## *06-206r1 SAS-2 iPASS™ Data Eyes vs. De-Emphasis*

SAS-2 Phy Working Group

5/1/06

## Jitter vs Length with Fixed and Optimal De-Emphasis

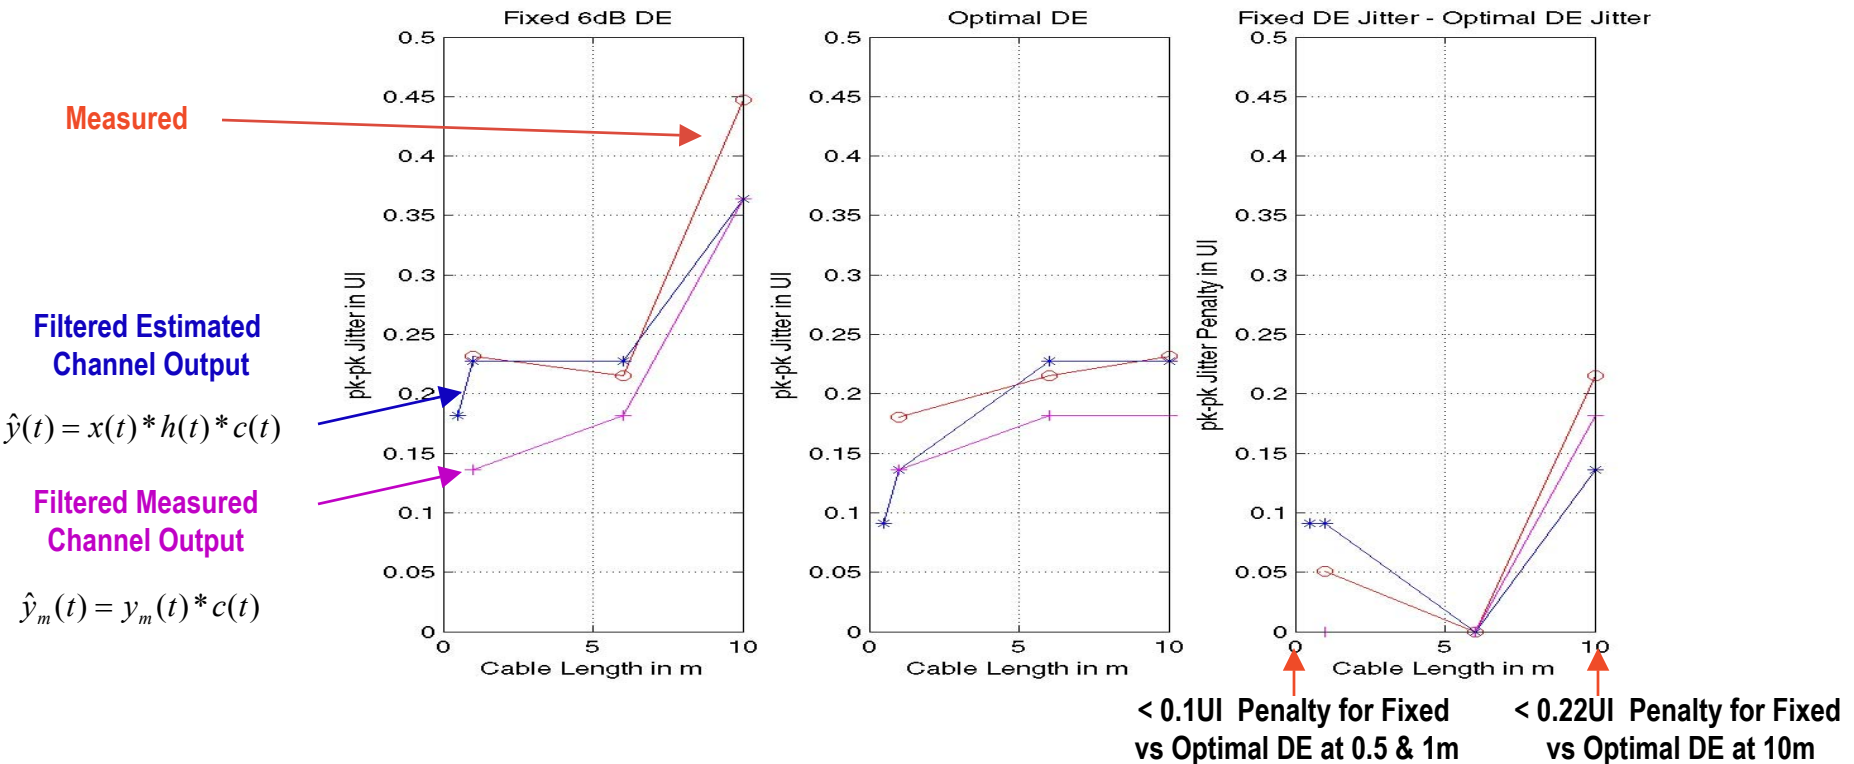
Minimum Length External Channel 0.5m Jitter is Simulated Only

Jitter Penalty at 10m is higher than at 1m length

- RE: T10/05-397r2 including IncEmp/Declmp,Done & NAK
- Otherwise We Fully Support T10/05-397r2

The data to date does not support the need for adaptive Tx De-Emphasis. 6dB of Fixed Tx De-Emphasis for external links does not appear to cause too much jitter when the short links are used.

My concern is that we add a requirement/option which is not proven to be needed; furthermore, if it is added as an "optional" feature it most likely will become required under the following scenario.

- Do not define “optional” primitives for adaptive De-Emphasis in the Training Sequence unless technical need determined.
- Do Specify a Fixed 6dB Fixed De-Emphasis for External Links.
- Do Provide Adjustable De-Emphasis for Internal Links.
- Do Assume a Maximum of 6dB De-Emphasis for Link Analysis and Specification.
- Determine a Compliance Test Methodology for External Links.
